VILLAWOOD

LEVEL 3 PLAN

Project no. 923 Dwg #. A106

DA - ADDITIONAL INFORMATION

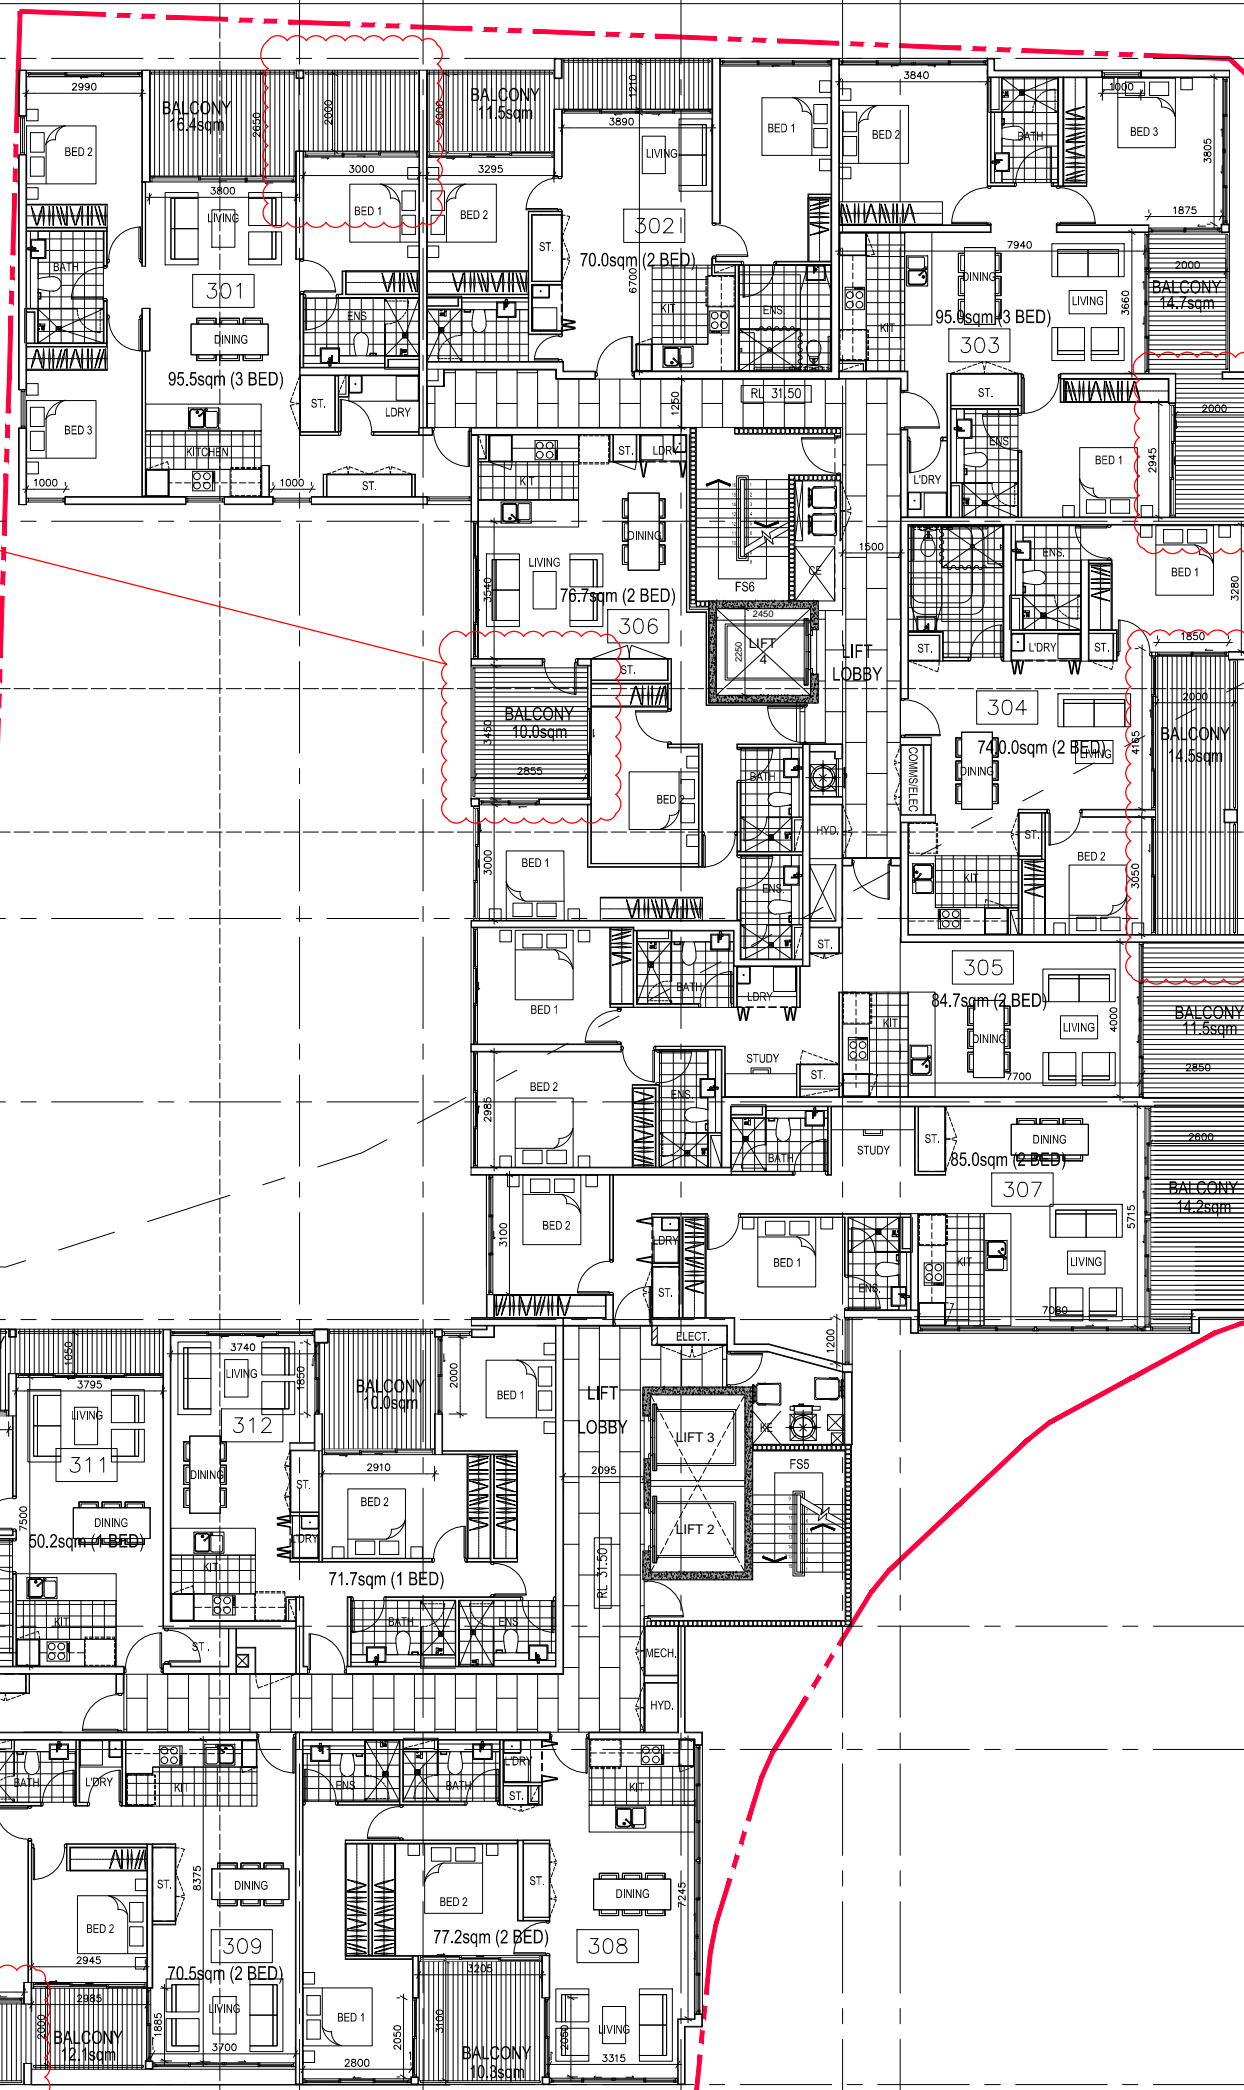
BALCONY DEPTH INCREASED TO ≥2 METERS IN DEPTH. (AS SHOWN IN CLOUDED AREAS)
